# UNITED STATES PATENT AND TRADEMARK OFFICE

10/518,326

Takaya Sato

<b>Office Action Summary</b>	<b>Application No.</b> 10/518,326	<b>Applicant(s)</b> SATO ET AL.	
	<b>Examiner</b> M'baye Diao	<b>Art Unit</b> 2809

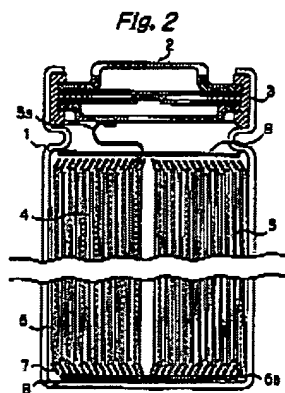
Kaminaka discloses (col.4, lines 1-18; col. 30, lines 37-67) and shows in Fig. 2 a non-aqueous electrolyte secondary battery equipped with a non-aqueous electrolyte and positive (5) and negative (6) electrodes which can reversibly occlude and release lithium. The positive electrode preferably comprises a lithium-containing transition metal compound as an active material, and the non-aqueous electrolyte is preferably a solution of a lithium salt dissolved in an organic solvent containing a carbonate ester. He further discloses (col. 4, lines 47-54) that the Si phase grains forming the core are an active substance for a negative electrode. By forming an intermetallic compound with Li (such as  $Li_{22}Si_5$ ), they can reversibly combine with and dissociate from lithium. Namely, at the time of charging, they combine with Li to occlude Li, and at the time of discharging, they disassociate from Li to release Li.

**FIG. 6**

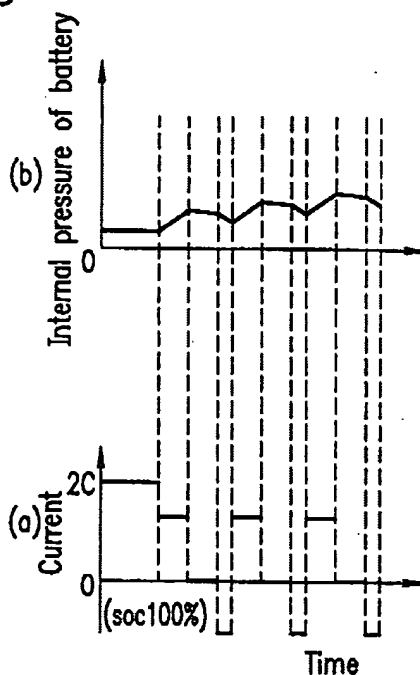
a central processing unit (CPU) (21) (applicant's charging processor), which is a part of the electric unit (70) (applicant's charging equipment for said rapid charge battery) as shown in Fig. 6, and;

As per claims 10 & 11, Uchida discloses (col. 4, lines 61-67; col. 5 lines 1-30) and shows in Figs. 6-7 & 9, the battery charging apparatus (applicant's battery charging system) comprising an electric device unit (70) (applicant's charging equipment of the rapid charge battery) which includes the CPU (21), ROM (read only memory) (22), a RAM (random access memory) (23), a MODEM (24), a network control unit (25), a card access unit (26), a battery detecting unit (27), a battery information reading unit (28), an energy discharging unit (35), a shutter drive unit (29), a door drive unit (30), a battery charging unit (31), a timer (32) for counting a clock, a solenoid drive unit (33) for driving the stoppers (49), and (52), a display unit (16), and an output battery information

Minamiura discloses (col. 5, lines 42-51) and shows in Fig.6 that after the battery pack is charged with a constant current at a rate of 2 C until the remaining battery capacity (SOC) reaches 100%, charging at a low rate of about 0.3-1.5 C, a suspension of charging, and discharging of the battery pack may be repeated in this order as shown in part (a) of Fig. 6. The charging at a low rate, the suspension of charging, and the discharging of the battery pack are each performed for an appropriate time period of about 10 seconds to about 40 minutes (representing applicant's different time and current for each time period).
